Interpretation Number: 2-07/03 (XGXS align status register bits)
Topic: XGXS align status register bits
Relevant Clause: Table 48-7 and 45-49
Classification: Unambiguous

Interpretation Request

1. Related Standard: IEEE Std 802.3ae-2002, clause 45.2.4 and clause 48

2. Related Standard: IEEE Std 802.3ae-2002, clause 45.2.4 and clause 48

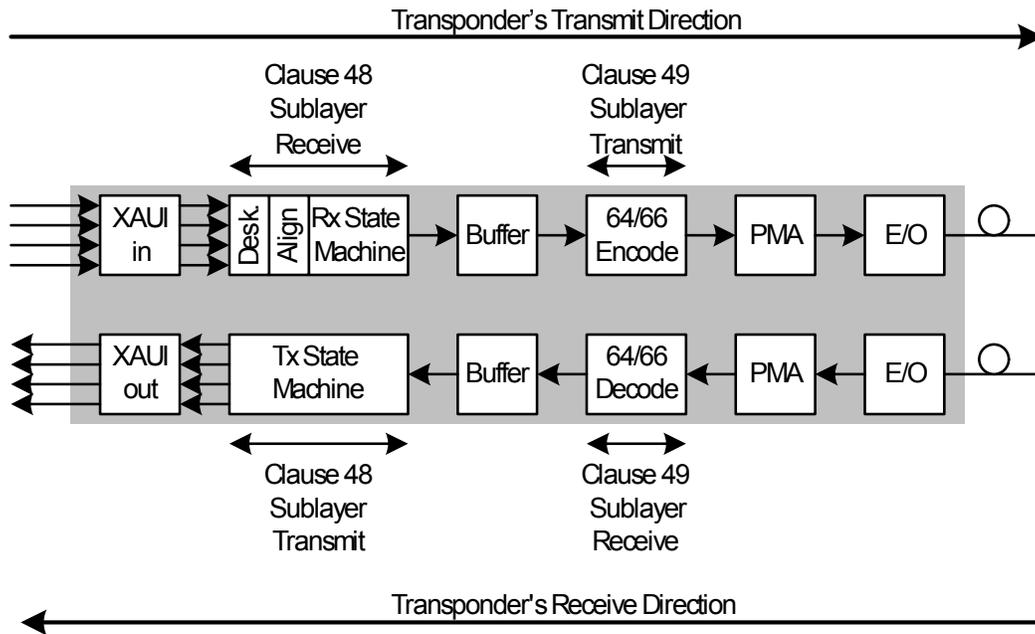
It appears that the description of how to use the terms “receive” and “transmit” is ambiguous, when using the specified sublayer in the following kind of 10GE transceiver application:

It should be made clear that clause 48 “receive” direction always corresponds to data incoming from XAUI (although might be called the transponder’s transmit direction) while the “transmit” direction corresponds to data sent to XAUI (which might be called the transponder’s receive direction).

This consequently leads to the following interpretation of status bits defined in clause 45.2.4:

Bit 4.8.11 (“Transmit Fault”) indicates a fault in the transponder’s receive direction.

Bit 4.8.10 (“Receive Fault”) indicates a fault in the transponder’s transmit direction.

We suggest to change the text in clause 45 to read as:

Clause 48 specifies the 10GBASE-X PMA and PCS and does not specify XAUI which, while built upon the 10GBASE-X PMA and PCS specification, is specified in Clause 47. In particular Figure 48-2 illustrates a 10GBASE-X PHY as stated in subclause 48.1.7, and not XAUI.

Within the Clause 47 XAUI specification, subclause 47.2.1 states 'Since the PHY XGXS operates with the XGMII below the XAUI, the transmit requirements of 48.2 and 48.3 apply to the PHY XGXS receive requirements and the receive requirements apply to the PHY XGXS transmit functionality.' As an example of this the PHY XGXS transmit function includes a lane alignment and therefore a PHY XGXS transmit lane alignment status bit is provided in subclause 45.2.4.8.1.

Based on this reversal defined in subclause 47.2.1 the bit definitions related to the PHY XGXS in Clause 45 are correct.
